DoD Lock Program

Technical Bulletin 19-002

Internal Locking Device (ILD) Key Guide Assembly (KGA) Detent Issue

Damage to key guide core.

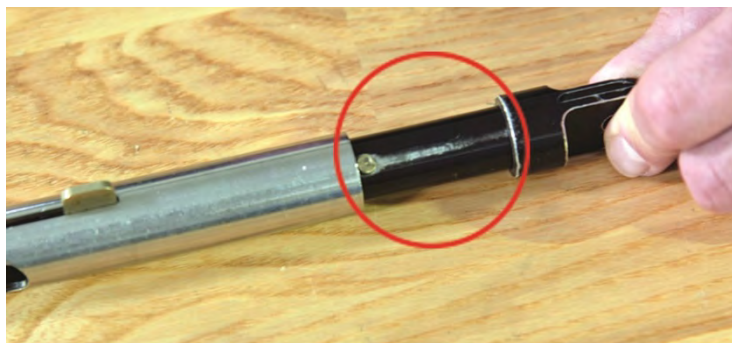
Symptom: The key guide shroud (silver tube in photos below) does not move smoothly, or the key guide shroud is stuck closed (covering the key).

Problem: The cause is a loose detent set screw binding against the key guide shroud.

Solution: Contact the DoD Lock Program Technical Support Hotline at (805) 982-1212, toll-free (800) 290-7607, or DSN 551-1212; or by email ILD_Field_Support@navy.mil for a replacement key guide assembly.
